Model Changes V6

Removal of South cavern detectors and infrastructure

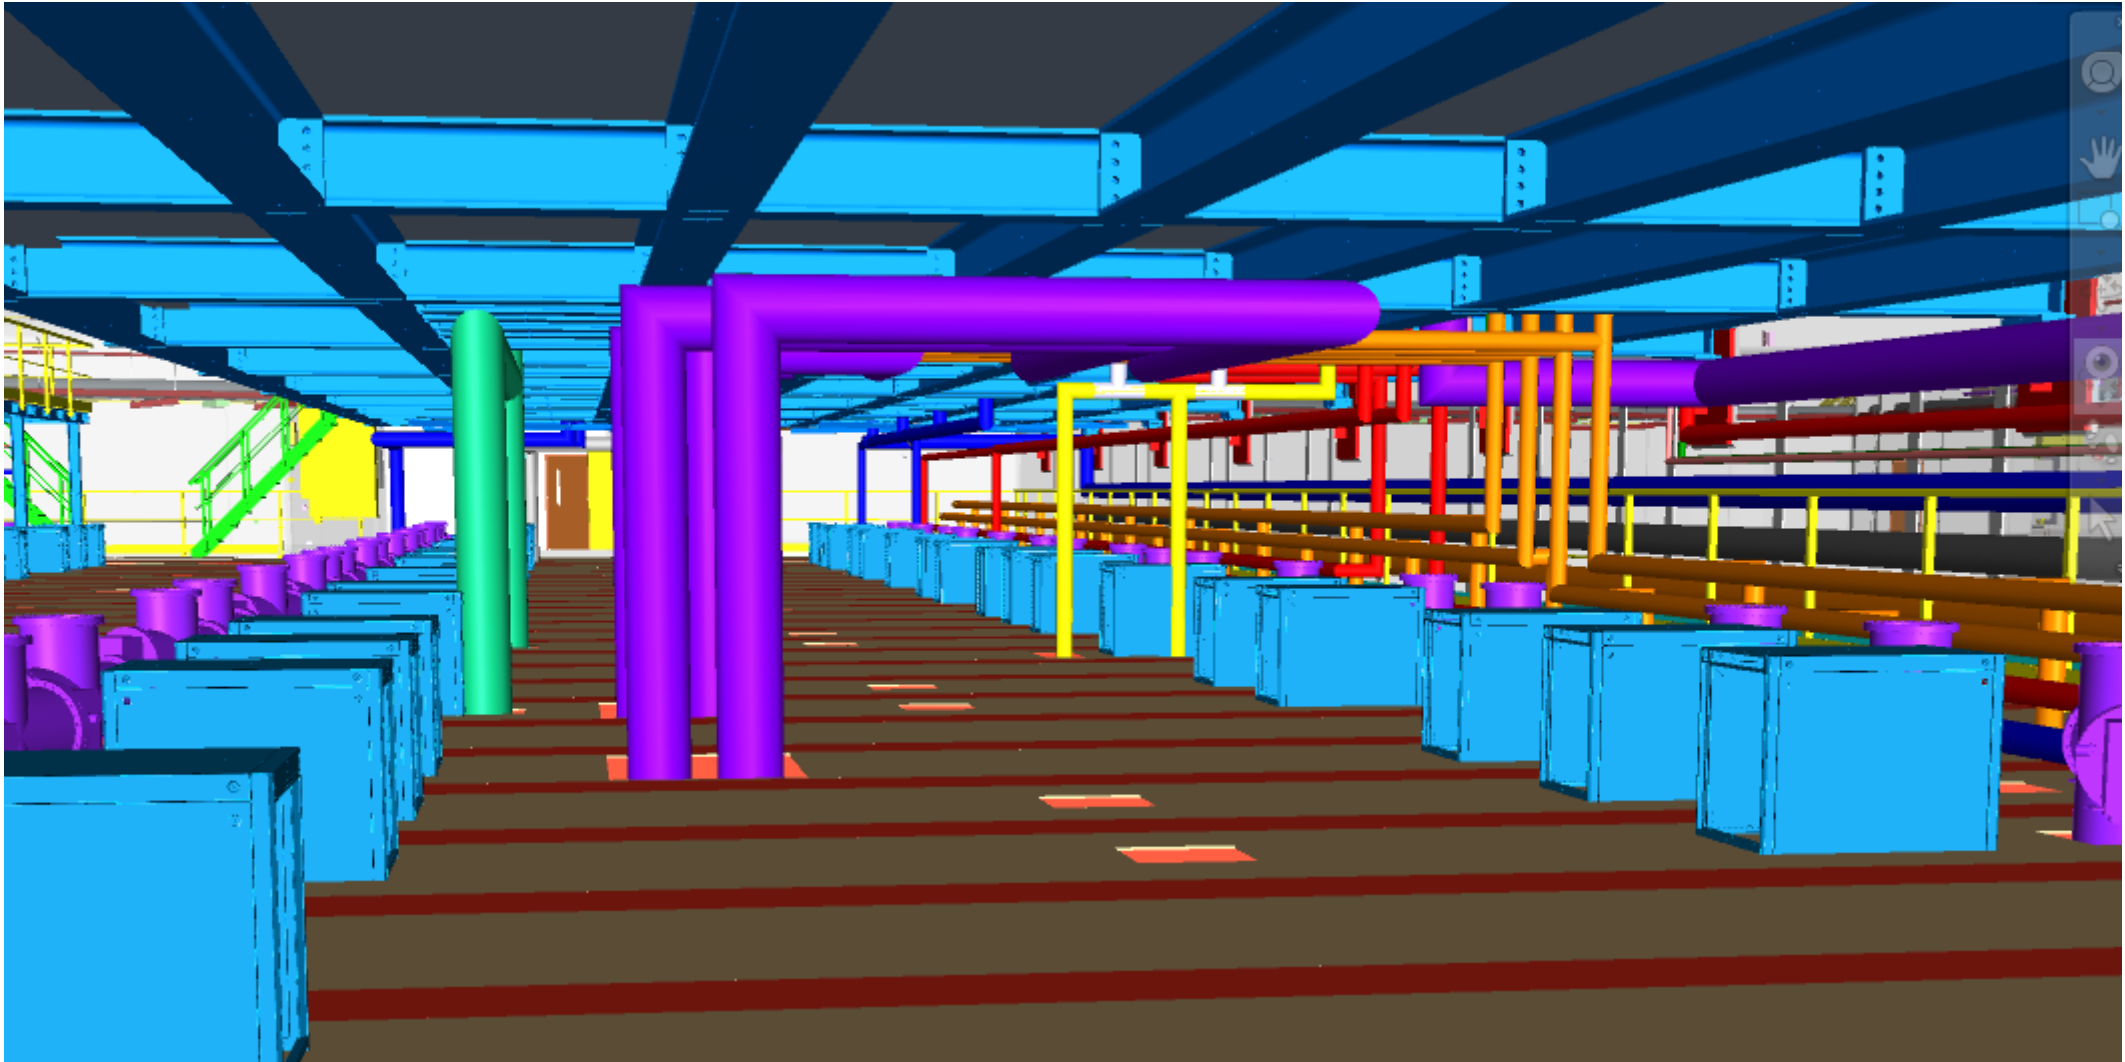
CE cable trays are asymmetric and APA conduits

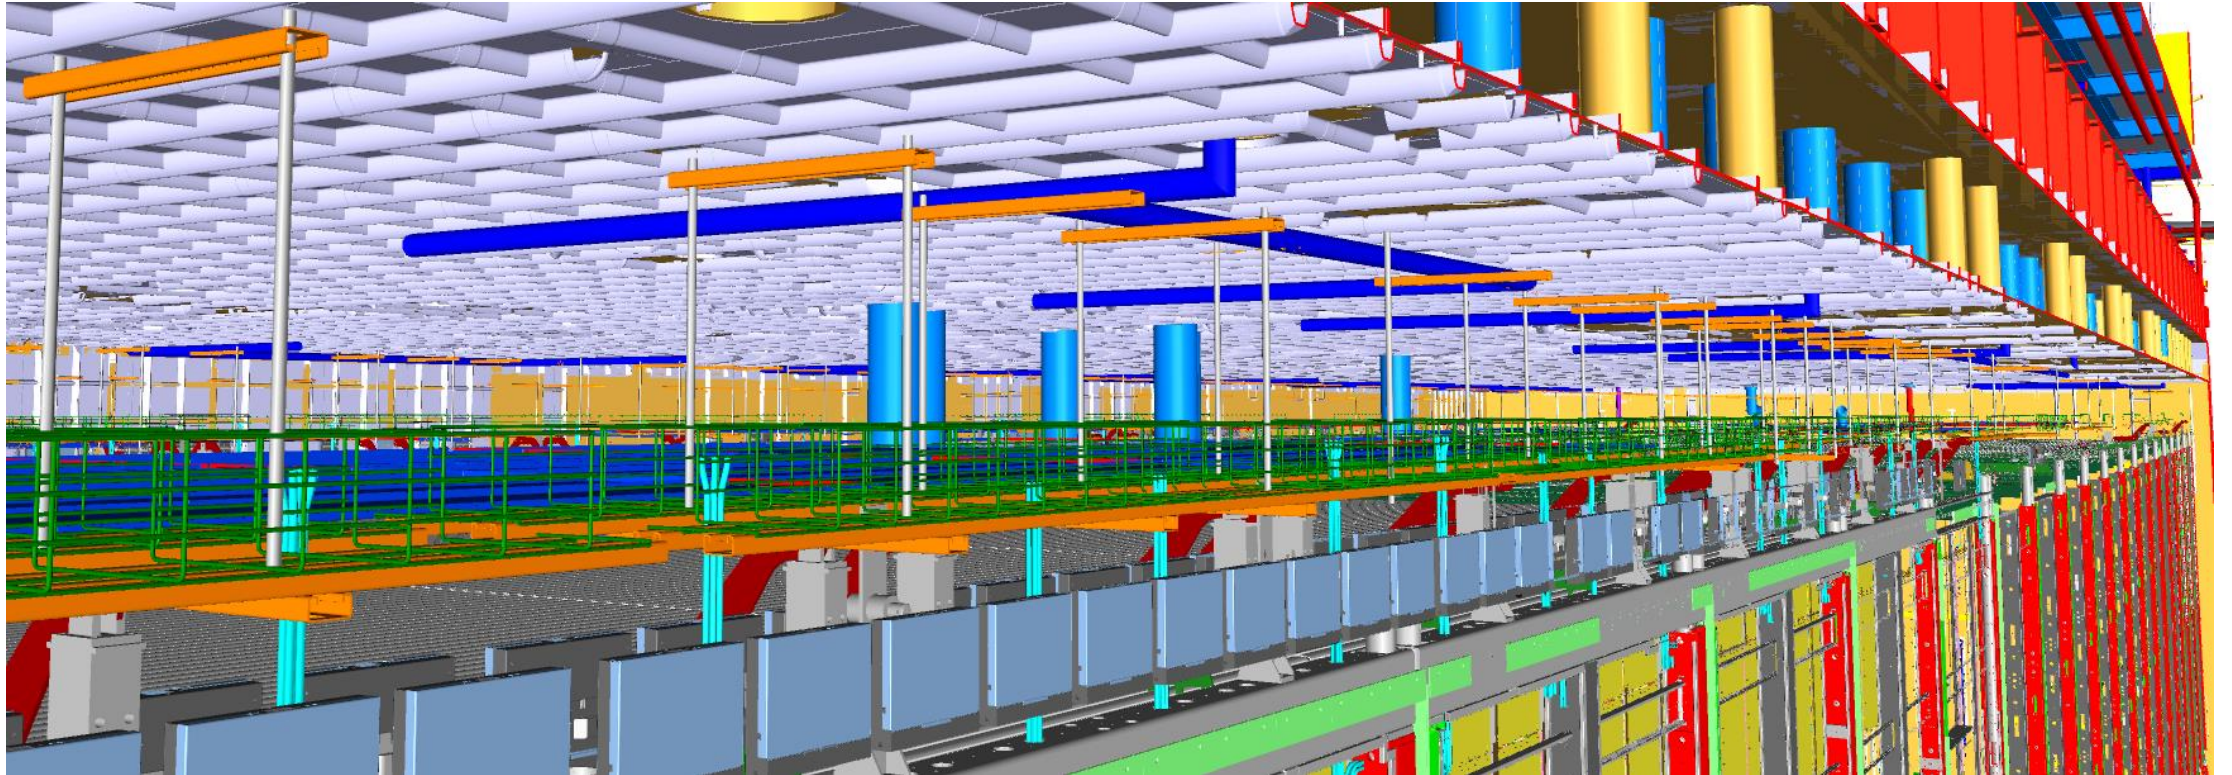
Update pipe sizes and routing to eliminate conflicts of cryogenic piping under the mezzanine

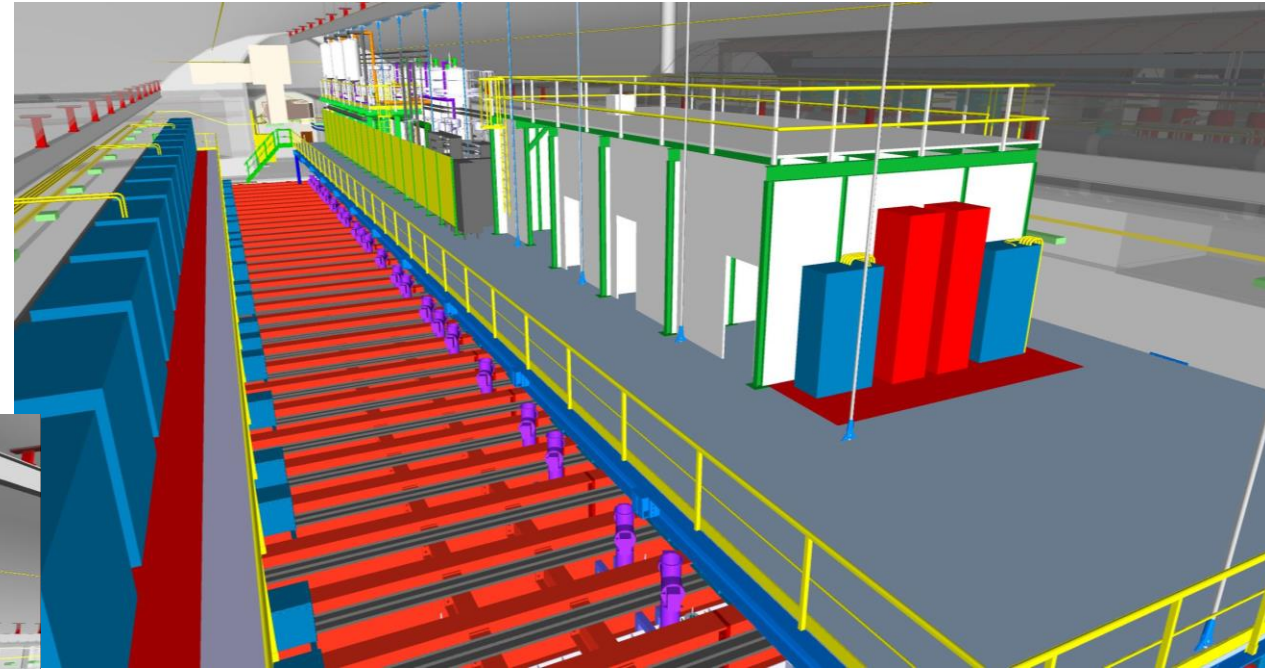
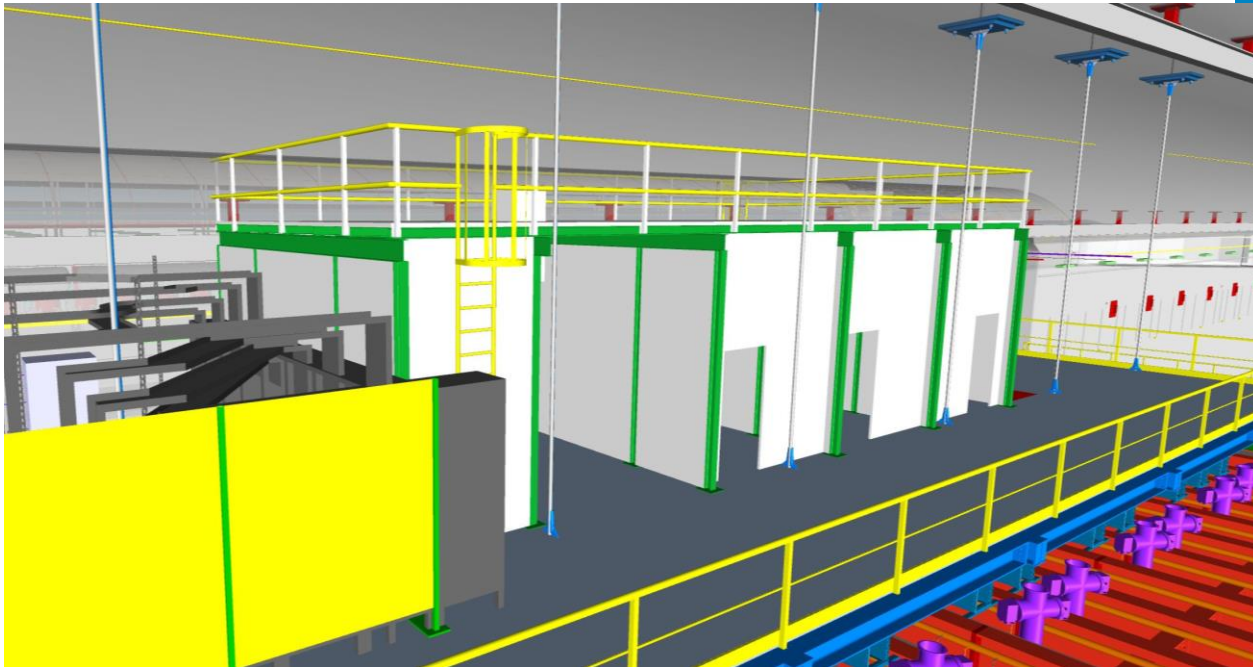
Updated internal cryogenic cooldown piping to avoid the detector

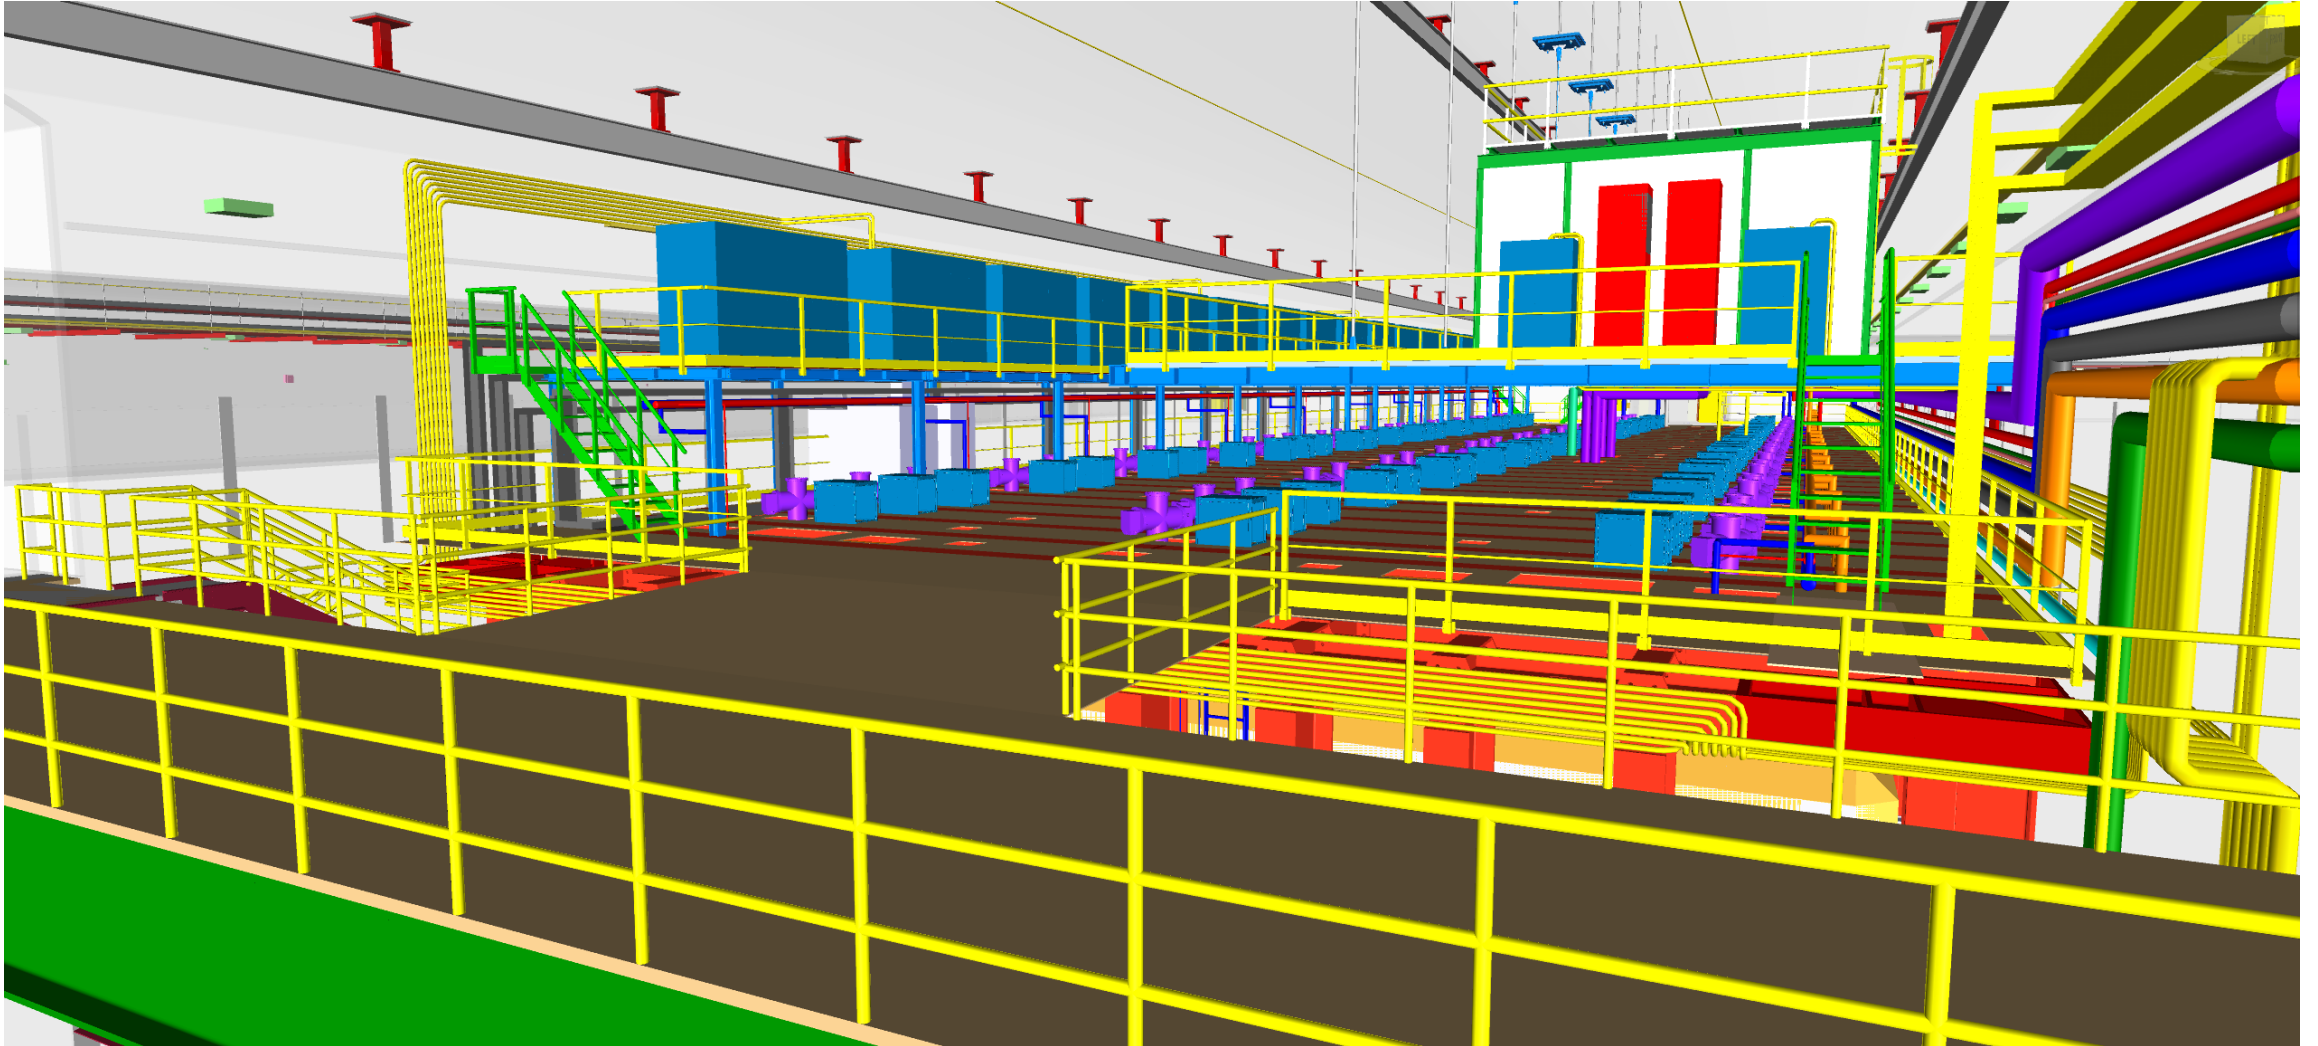
New barracks on the cryogenic mezzanine to accommodate
DAQ move from CUC

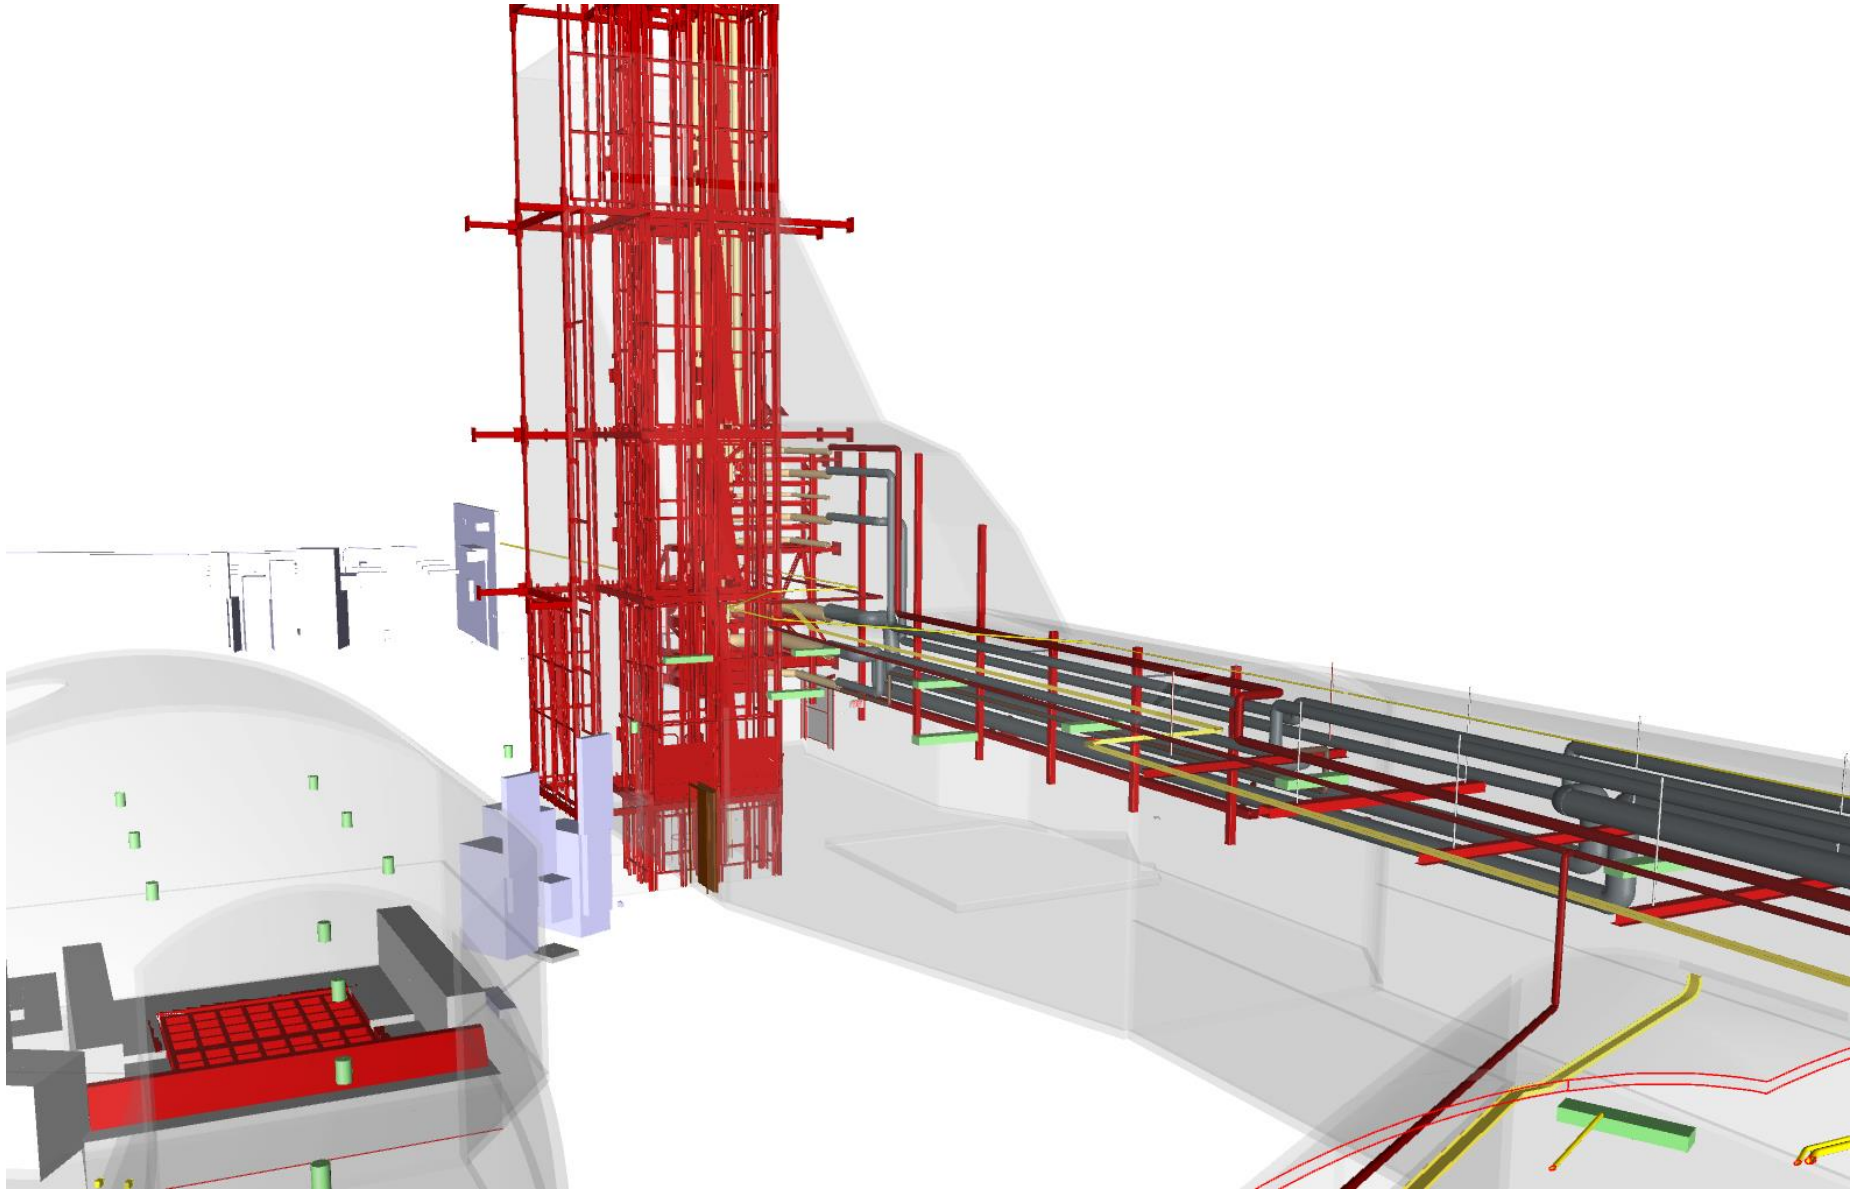
Additional platforms and railings for safe access
